Louisiana Energy Services, L. P.  
National Enrichment Facility  
NRC Docket No. 70-3103

**Subject:** Response to NRC Request for Additional Information Regarding the National Enrichment Facility Environmental Report

**Louisiana Energy Services  
Response to April 29, 2004,  
Request for Additional Information**

Figure ER RAI 4-1.2

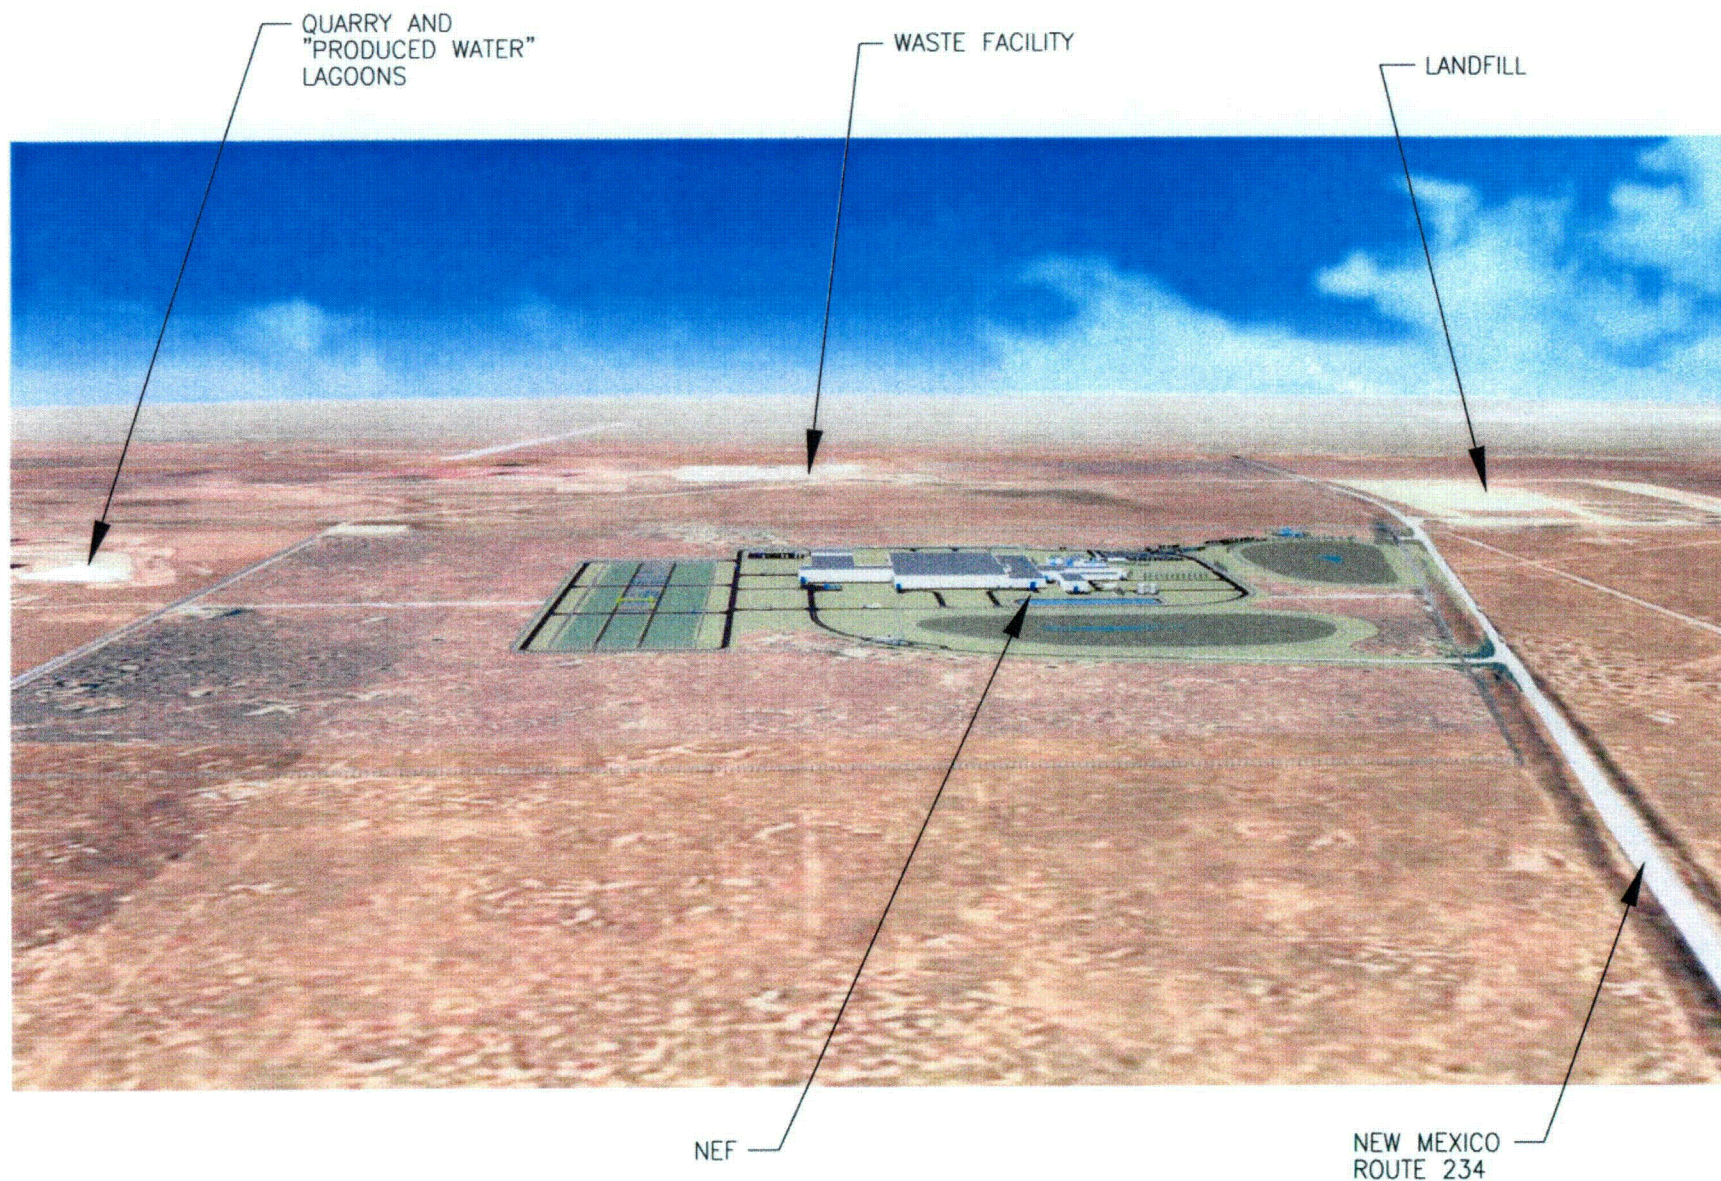
Provide a copy of the artistic rendering showing a view of the proposed NEF and how it would visually impact the site and surrounding area.

Figure ER RAI 4-1.1, "Aerial View," is an artistic aerial view of the NEF and surrounding area. Figure ER RAI 4-1.2, "View to the Northwest," Figure ER RAI 4-1.3, "View to the East," Figure ER RAI 4-1.4, "View to the South," and Figure ER RAI 4-1.5, "View to the West," in Attachment 3 to this submittal, provide artistic views of the NEF site and vicinity, looking to the northwest, east, south and west, respectively. The quarry and "produced water" lagoons to the north, the existing Waste Control Specialists (WCS) waste facility to the east, the county landfill to the southeast and New Mexico Route 234 to the south are shown in relation to the NEF site. Land to the west, occupied by a petroleum contaminated soil treatment facility, is undeveloped. Viewing the surrounding area from the NEF site, and looking northward, the quarry and "produced water" lagoons are at a higher elevation. To the east, several low-rise buildings associated with the WCS waste facility are apparent at a distance. Earthen mounds are apparent to the southeast, across New Mexico Route 234. No structures are visible on the adjacent property to the west.
